**SUBDIVISION, PLANNED UNIT  
DEVELOPMENT & SIDEWALK WAIVER  
REQUEST STAFF REPORT****Date: September 6, 2012**

<b><u>NAME</u></b>	Chipco Industrial Park, Blakeley Island Subdivision
<b><u>SUBDIVISION NAME</u></b>	Chipco Industrial Park, Blakeley Island Subdivision
<b><u>LOCATION</u></b>	581 Cochrane Causeway (West side of Cochrane Causeway, 3/4± mile North of Bankhead Tunnel)
<b><u>CITY COUNCIL DISTRICT</u></b>	District 2
<b><u>PRESENT ZONING</u></b>	I-2, Heavy Industry District
<b><u>AREA OF PROPERTY</u></b>	2 Lots/37.1± Acres
<b><u>CONTEMPLATED USE</u></b>	<i>Subdivision</i> approval to create two legal lots of record, <i>Planned Unit Development</i> approval to allow multiple buildings on multiple building sites with shared access between building sites and <i>Sidewalk Waiver</i> approval to waive construction of sidewalks along Cochrane Causeway.
<b><u>TIME SCHEDULE</u></b>	None Specified

# DETAIL SITE PLAN

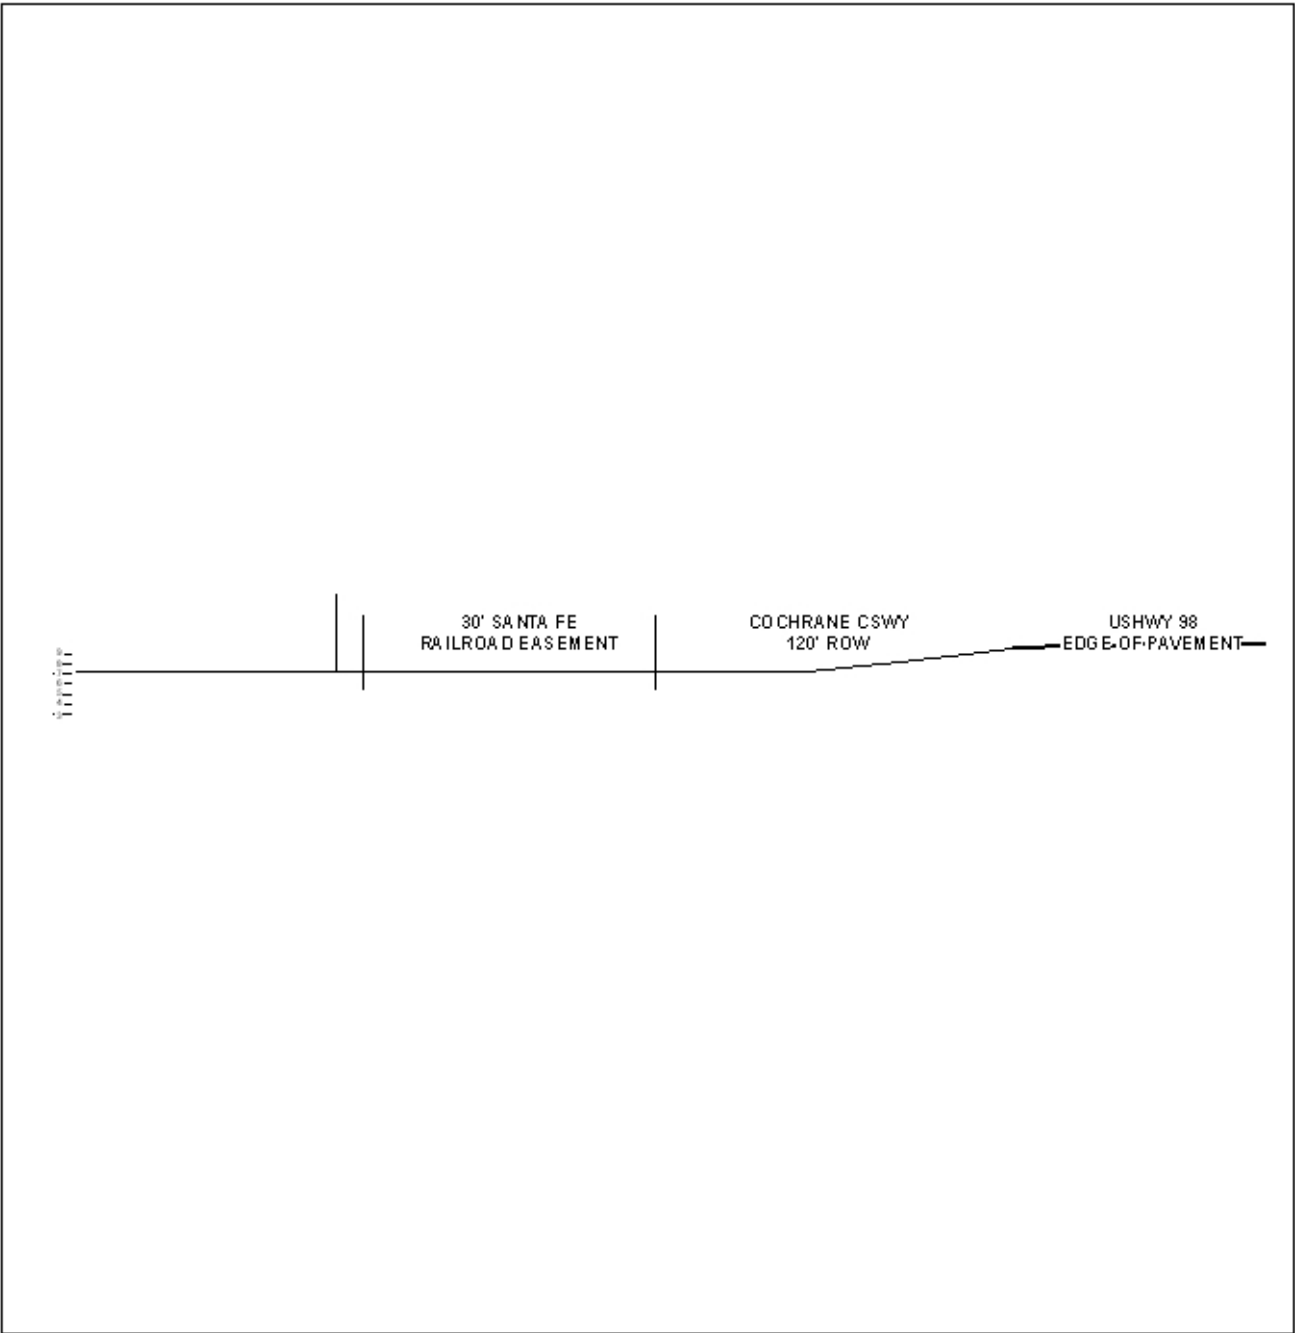
Dumpster locations for the site are not depicted on the site plan to comply with Section 64-4.D.9. of the Zoning Ordinance; therefore, the applicant should make a provision for dumpster locations and place a note on the site plan stating that dumpsters will be completely screened from view. If dumpsters will not be used, provide a statement indicating such, and how garbage will be removed from the site.

The 25-foot minimum building setback line is not depicted on the plat along Cochrane Causeway within the proposed building sites; therefore, the preliminary plat should be revised to show the 25-foot setback line along Cochrane Causeway within the proposed building site.

The Final Plat should also provide the labeling of the lots with its size in square feet/acres, or placement of a table on the plat with the same information

Another issue that should be pointed out, but could be considered non-critical to the development of the site(s) is landscaping. The applicant provides landscaping and tree plans of the existing site, the plan illustrates full compliance with the tree planting regulations; however, the site is

short in the total and front landscaping percentages of the Zoning Ordinance. The site is 37.1+ acres; therefore, 12 percent of the **total** site must be landscaped, of this 12 percent, 60 percent of the landscaping must be located between the building and the right-of-way. On the majority of commercial developments, this would be an issue; however, on large industrial developments such as this and others along Cochrane Causeway, it can be due to the close proximity of the Mobile River and the type of services provided at these locations. It is recommended that the site be allowed to provide the existing landscaping, due to the nature of the site. Therefore, the site plan should be revised to reflect the existing landscaping and frontage landscaping square footage and percentages. It should also be noted that the as site is zoned I-2, **ONLY** frontage trees are required.

- 1) revision of the site plan to illustrate the 25' minimum building setback line along Cochrane Causeway;
- 2) revision of the site plan to provide the location of the required trees, providing the required spacing to allow for compliance with Homeland Security and the Coast Guard standards, to be coordinated with Urban Development;

- 3) revision of the site plan to provide the existing total and frontage landscaping square feet and percentages;
- 4) revision of the site plan to provide a dumpster, in compliance with Section 64-4.D.9. of the Zoning Ordinance, or the placement of a note on the site plan stating that trash collection will be curb-side or via private pick-up service;
